Addendum No. 1
February 15, 2018

Project: Brandon Valley High School Classroom Remodel
Brandon, South Dakota

Project #: 2747

Architect: Architecture Incorporated

**CLASSROOM UNDERFLOOR PLAN -
PLUMBING**

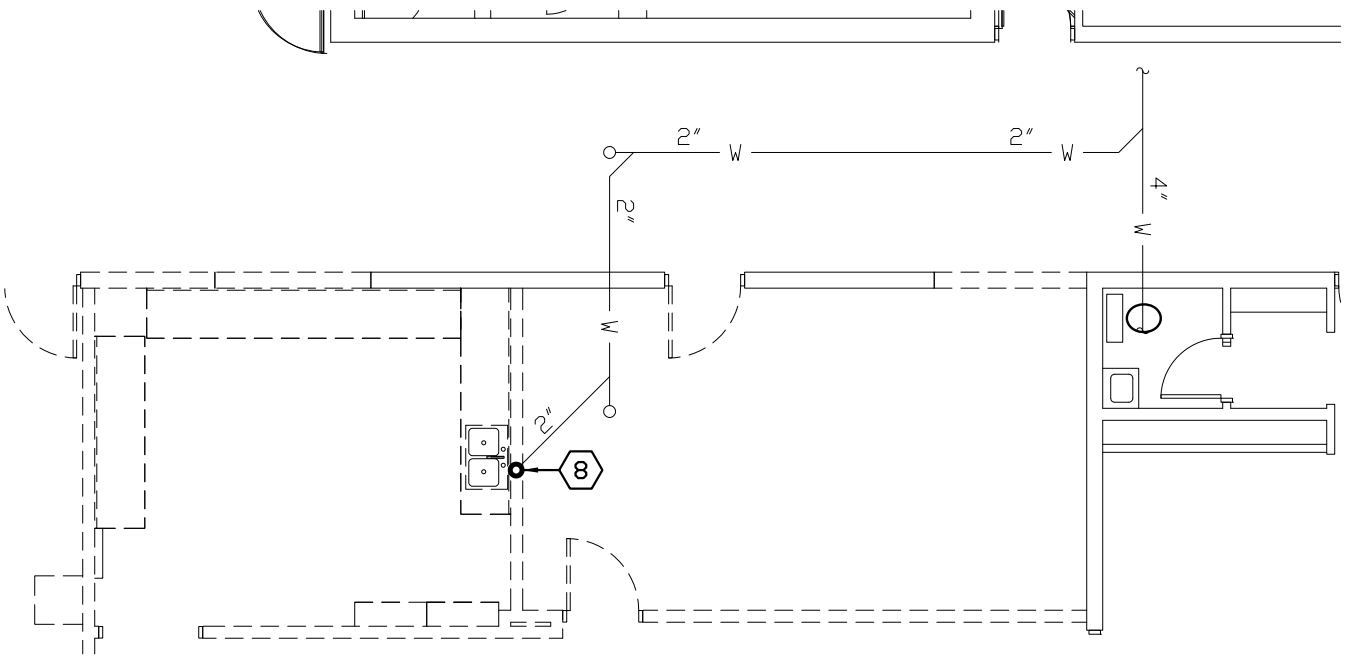
- a) CLASSROOM UNDERFLOOR PLAN – PLUMBING
 - i) 2” waste piping serving sink to be capped at floor. No capping of waste piping in corridor is required. Refer to attached drawing sheet R8.20, 1 of 1, dated 2-15-18.

**CLASSROOM UNDERFLOOR PLAN -
DEMOLITION - PLUMBING**

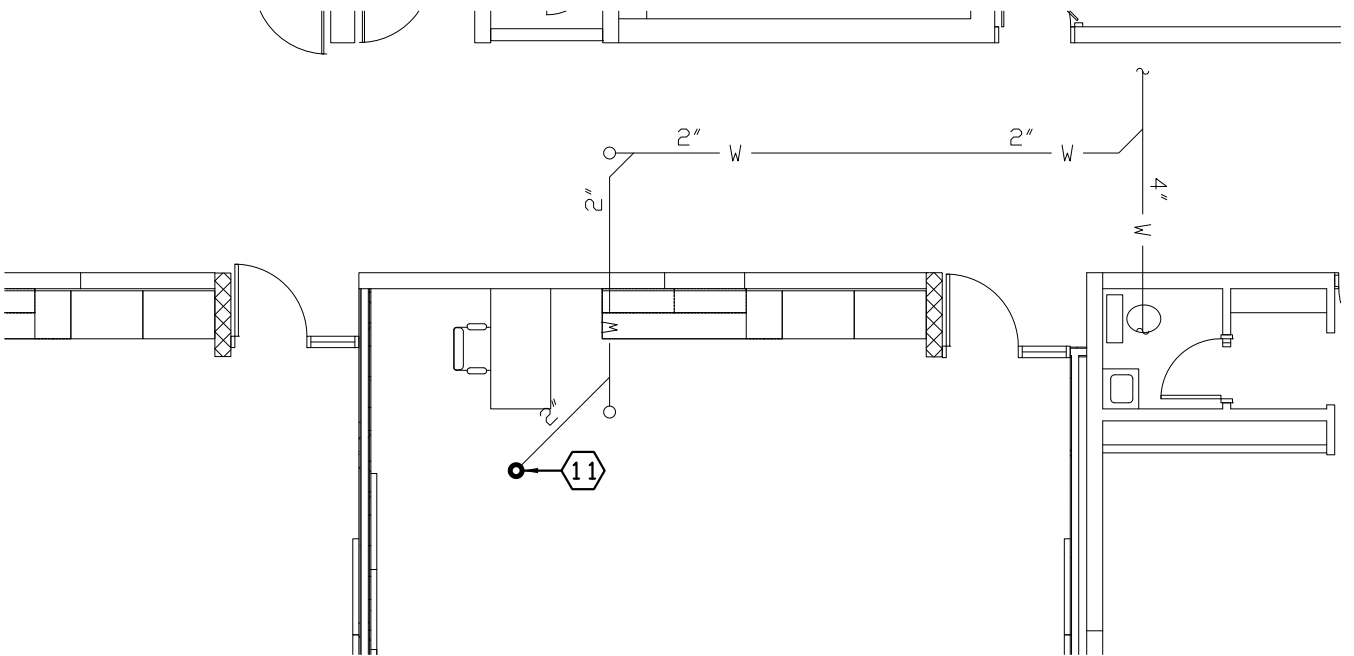
- a) CLASSROOM UNDERFLOOR PLAN – DEMOLITION – PLUMBING
 - i) 2” waste piping serving sink to be capped at floor. No capping of waste piping in corridor is required. Refer to attached drawing sheet R8.20, 1 of 1, dated 2-15-18.
